Test Drive Results and Revisions of the New Stream Restoration Crediting Protocols

Bill Stack
&
Lisa Fraley-McNeal

Urban Stormwater Workgroup
November 19, 2013

Step 2. Determine the dimensions of the hyporheic box

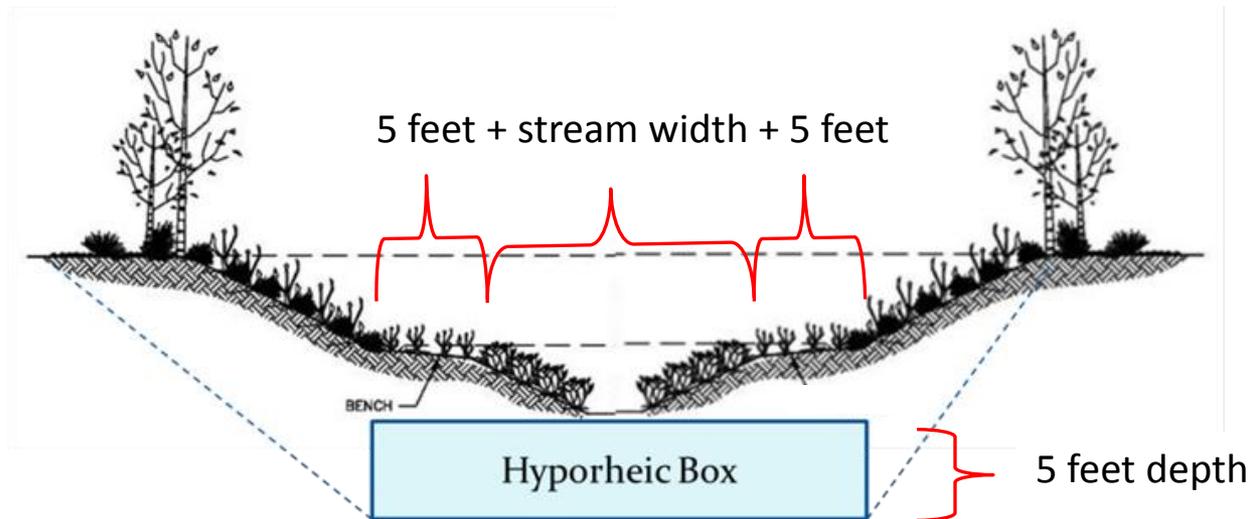
Concern: Load reductions from Protocol 2 can be high and in some cases exceed watershed loading rates.

- Add a qualifying condition that TN load reduced cannot exceed 40% of the total watershed TN load.
- Current denitrification rate (1.95×10^{-4} lbs N/ton/day of soil) is an average of the low bank restoration sites in Minebank Run. Revise the rate so it is an average of both the high and low bank restoration sites (0.96×10^{-4} lbs N/ton/day of soil).

Justification: Klocker (2009) found that 40% of the daily load of nitrate in Minebank Run could be removed. In addition, the lower denitrification rate would provide a more conservative estimate to account for the variability in measured denitrification rates.

Step 1. Estimate the floodplain connection volume

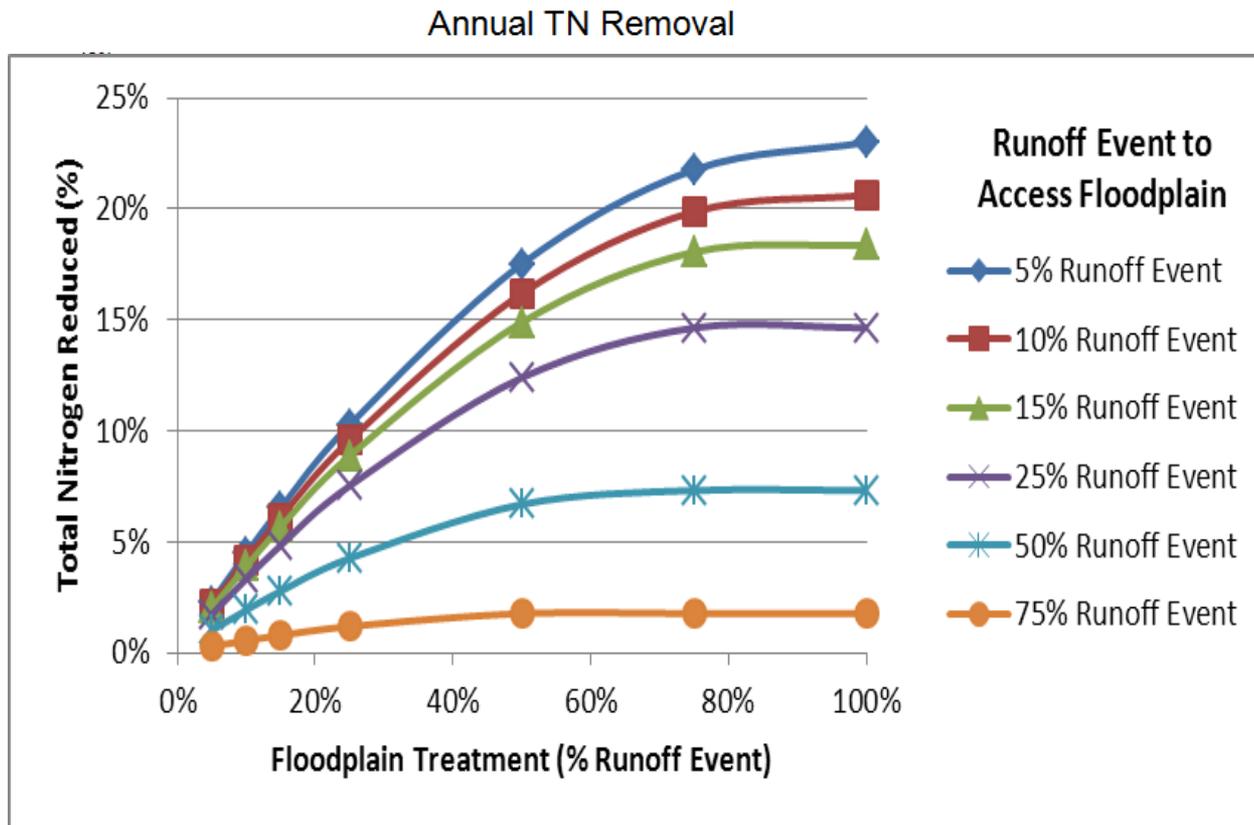
Concern: The curves used to develop Protocol 3 are not accurate enough for design purposes.

Concern: The pre-restoration condition was not accounted for in the Protocol.

Solution: Include a better description of how the curves were developed and how other methods can be used, such as an alternate method presented in Appendix G that uses the Soil Conservation Service Runoff Curve Number.

Solution: Include pre-restoration assessment and qualifying conditions.
